Company	Trenz Electronic GmbH
PCN Number	PCN-20210216a
Title	TE0712-02 DDR3, Flash Change and Product Update
Subject	BOM change
Issue Date	(2021-02-17), Revised 2021-03-09

This change affects all Trenz Electronic TE0712 SoMs of revision 02: TE0712-02-*

3 Method of Identification

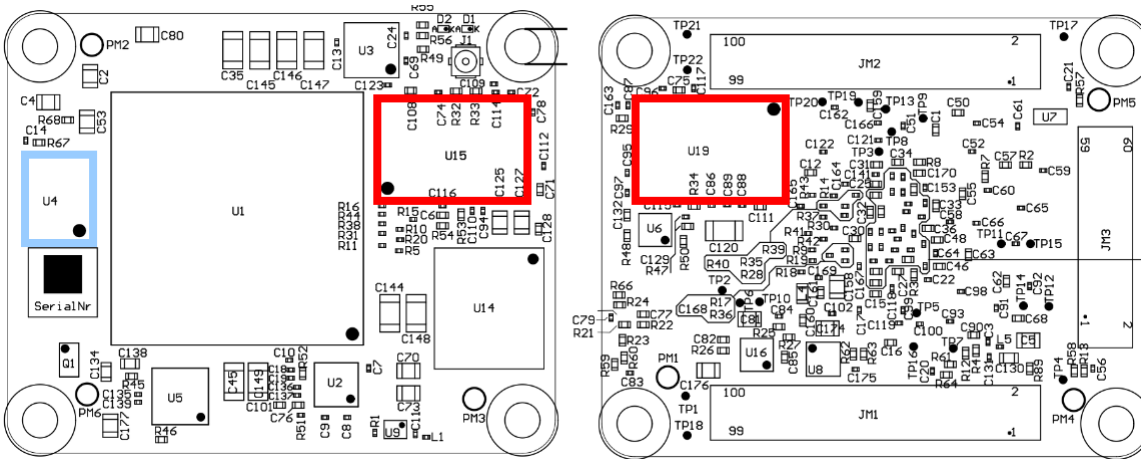
Locate DDR3 RAM (U15 top, U19 bottom) and Flash (U4 top) on PCB:

old	new
IM4G16D3FABG-125I	IS43TR16256BL-125KB LI

old	new
<p style="text-align: center;">S25FL256SAGBH120 or MT25QL256ABA8E12-1SIT</p>	<p style="text-align: center;">IS25LP512M-RHLE</p>
<div style="text-align: center;">  <p>TE0712-02-2CA and TE0712-02-72C03-M only:</p>  </div>	<div style="text-align: center;">   </div>
